ISSUE: Permit to Demolish/Capsulate (partial) and Certificate of Appropriateness for alterations, Waiver of Rooftop Mechanical Screening

LOCATION: Parker-Gray District
1000 Cameron Street

**BAR #2022-00360 & BAR #2022-00361**
1000 Cameron Street

Figure 4: Proposed south elevation

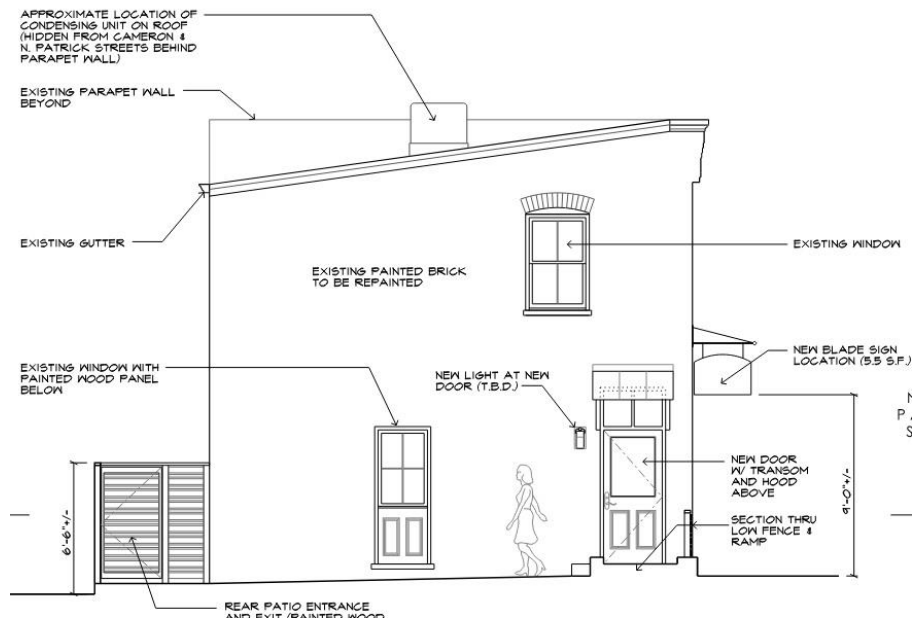
As noted above, adding a door on the south elevation will require the removal of approximately 29 square feet of masonry, but will provide a much-needed accessible entrance with a ramp. It will also better balance the elevation. See Figure 4. Staff suggests that, if possible, the masonry removed to create this entrance be used to fill in the door/window opening on the east elevation. The door itself will be wood panel below single-lite glass. Staff notes that the glass must be without tint and non-reflective in order to comply with the *Parker-Gray Residential Reference Guide*.

Staff recommends approval of the project with the conditions that the glass in the picture window on the east elevation and the door on the south elevation is neither tinted nor reflective and, if possible, use the brick to be removed from the south elevation for a new doorway to infill the existing opening on the east elevation which will be closed. Staff also notes the recommendations of Alexandria Archaeology.

Figure 5: Proposed east elevation

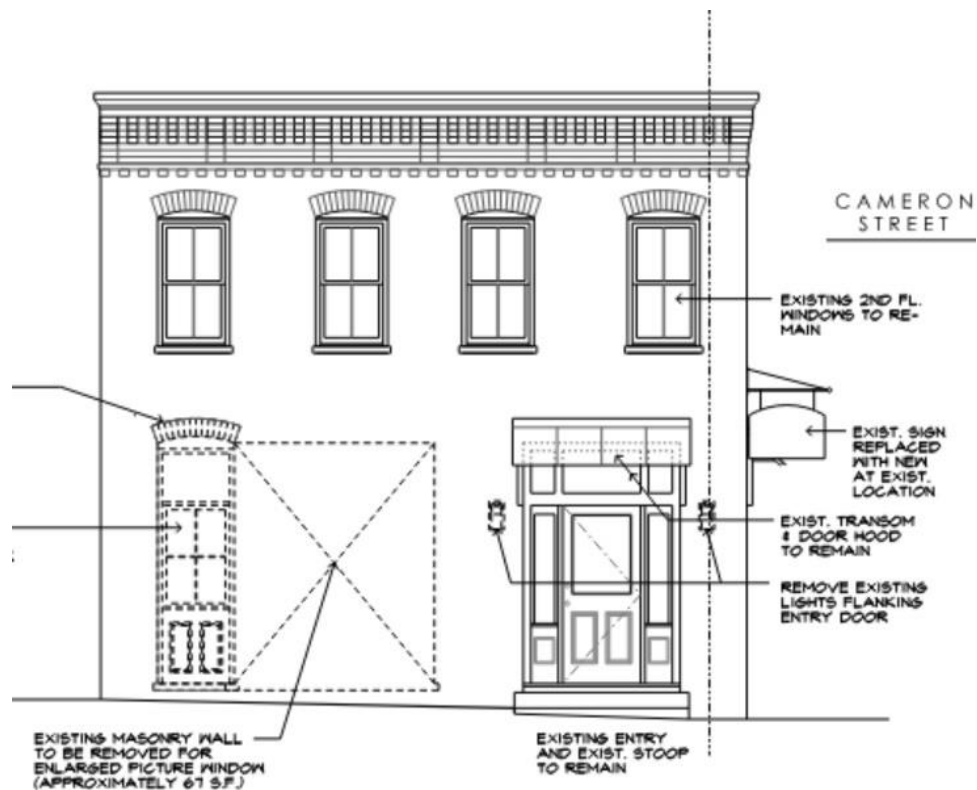
The most substantial alteration proposed in this application is the addition of a picture window on the primary/east elevation. As shown in Figure 1, this elevation currently looks blank and unfinished with a large expanse of empty wall. Adding a picture window here will greatly enhance the elevation, providing a more attractive and welcoming façade. See Figure 5. Staff recognizes that the proposed window is not centered between the two windows above it on the second floor, which would normally be the preferred location. While centering the window would be the ideal

option, doing so is not feasible due to the interior configuration and future usage of the building. City Code requires 60” of open space from the face of the accessible door on the south elevation into the room where the window will be located. The owner would like to provide bar-height seating at this window with a narrow countertop running across the inside of the window which will enable customers to look out onto North Patrick Street while having their coffee. If the window is centered, this counter would have to be almost entirely eliminated as it cannot protrude into the Code-required floor area. Staff notes that glass for this window must be non-reflective and without tint.

1000 CAMERON STREET
 NORTH PATRICK STREET ELEVATION
 PROPOSED DEMOLITION

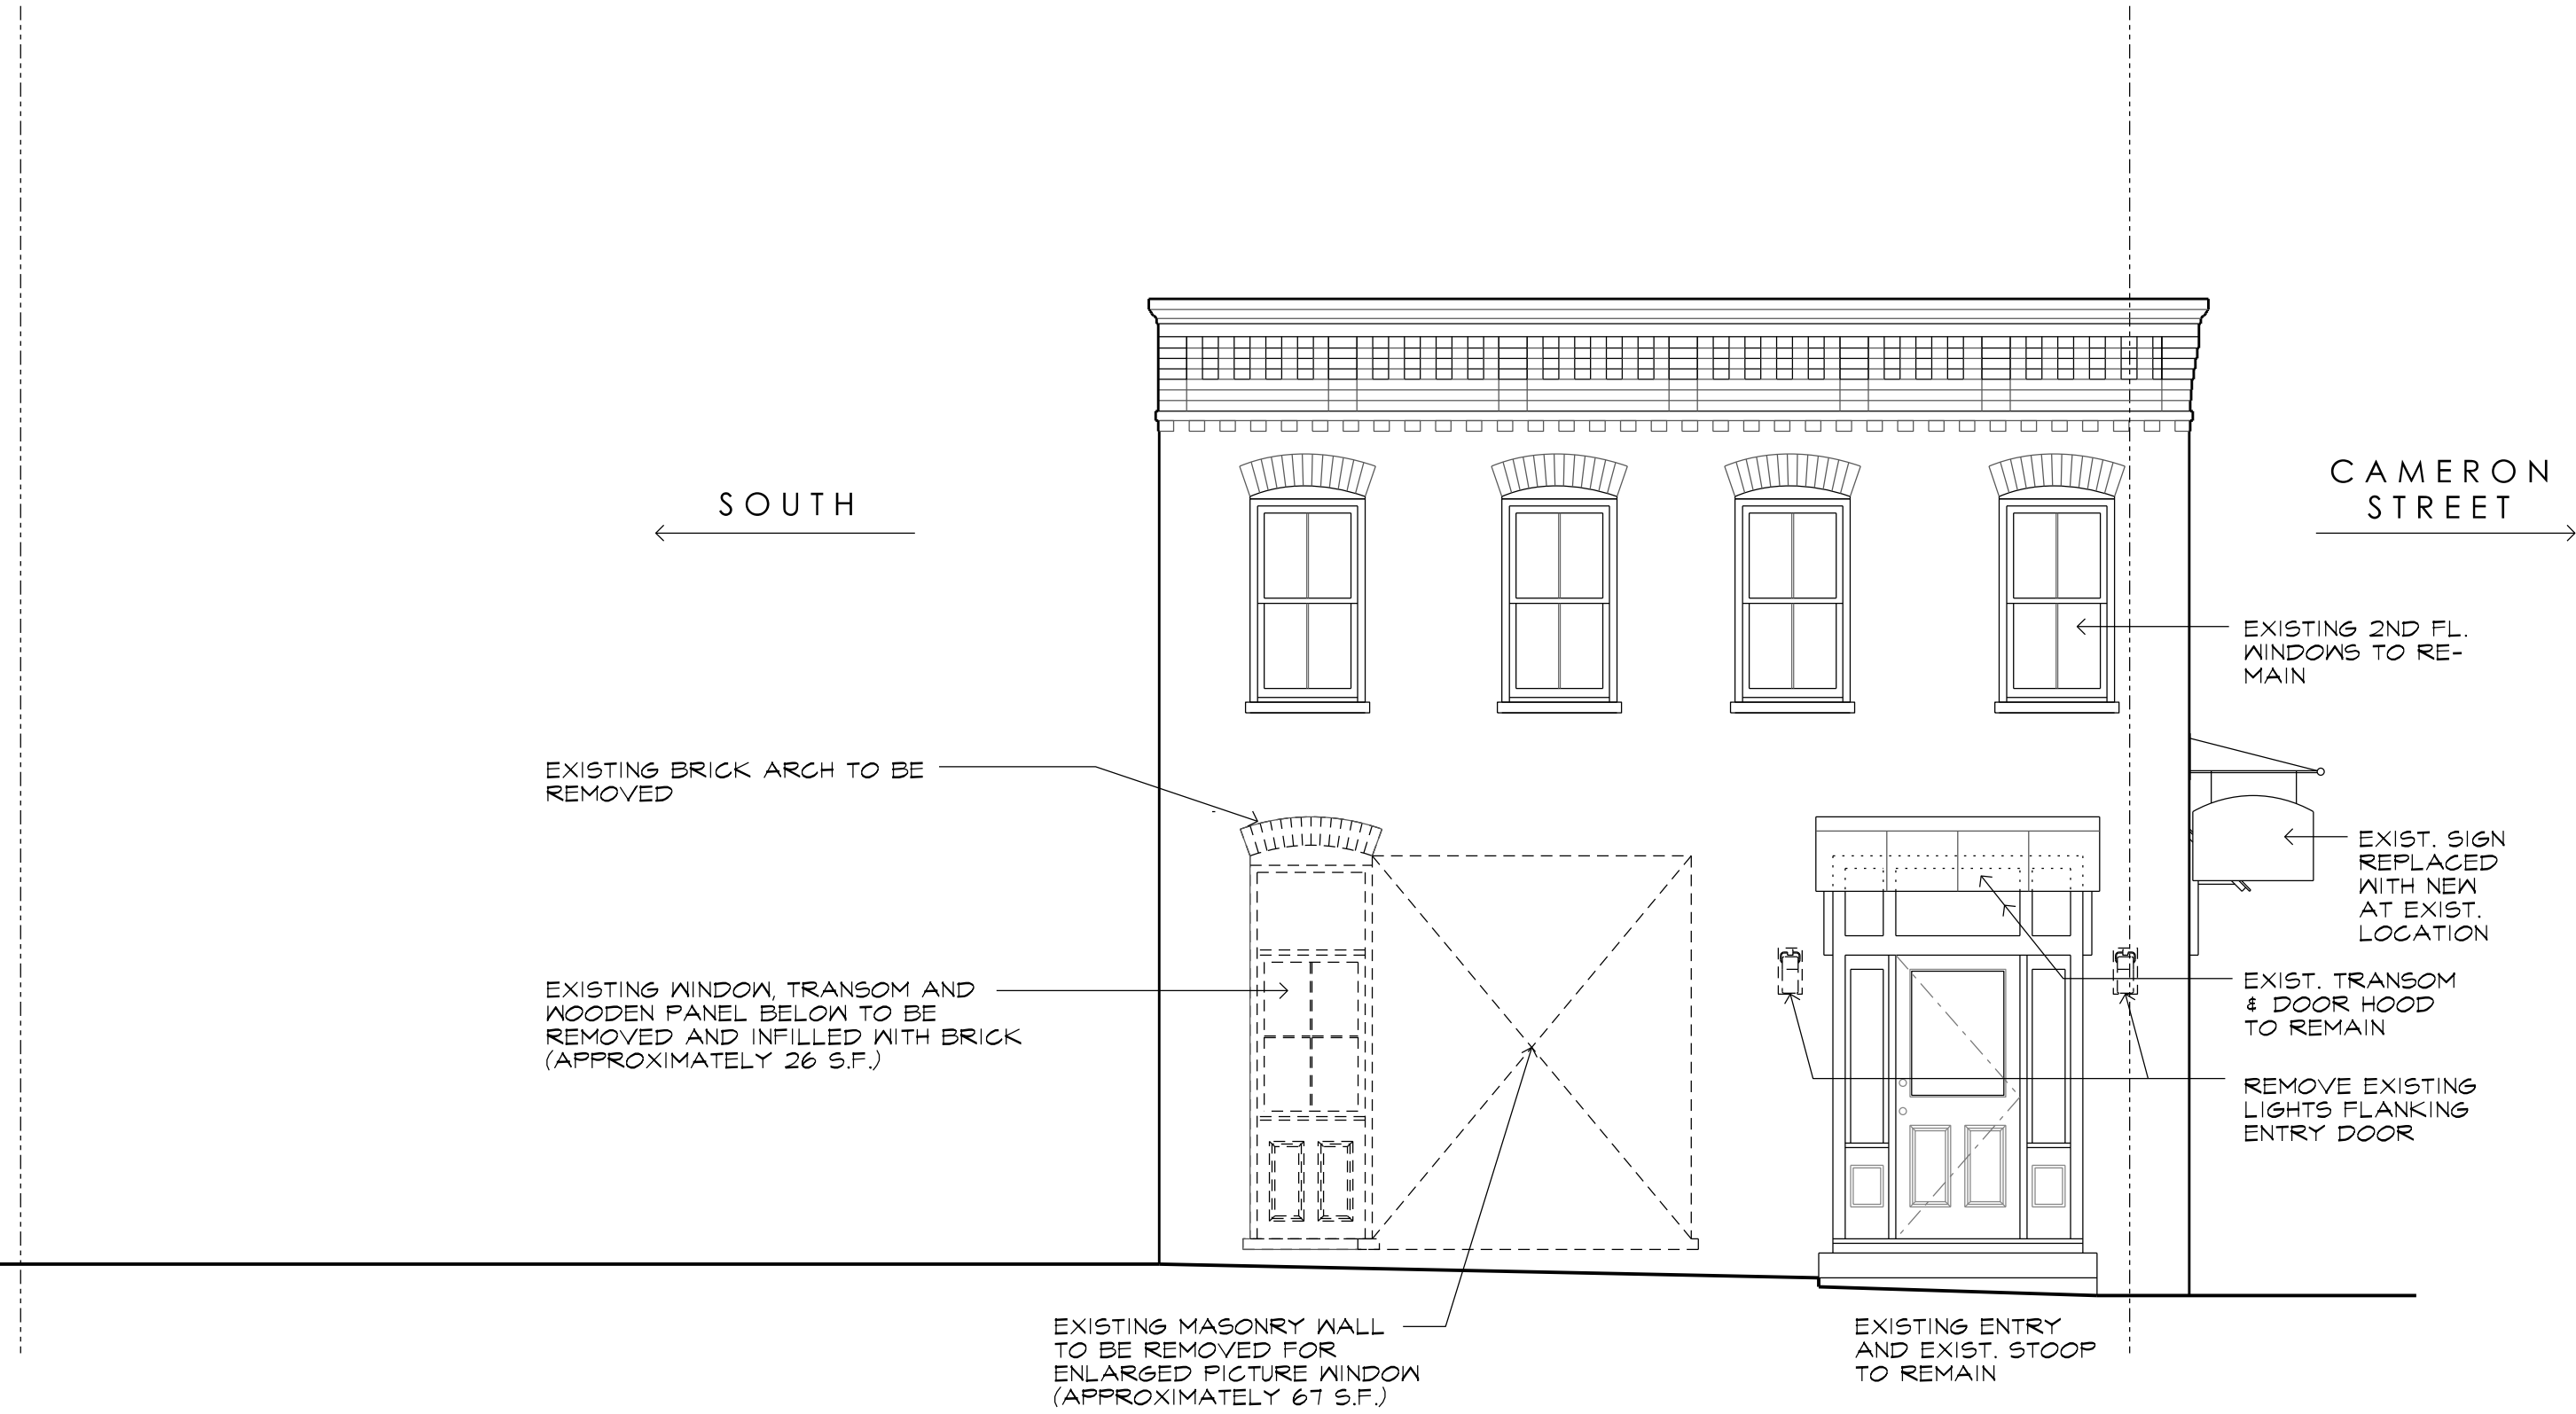
While the some of the areas to be demolished may possibly date to the original construction, the brick laid in seven-course American bond is not of unusual or uncommon design and can easily be replicated today. Physical evidence indicates that several changes have been made to the exterior of the building over time. The east elevation of the building may have had an opening, or possibly two openings, in the area of the proposed picture window at some point in its history. See Figure 1.
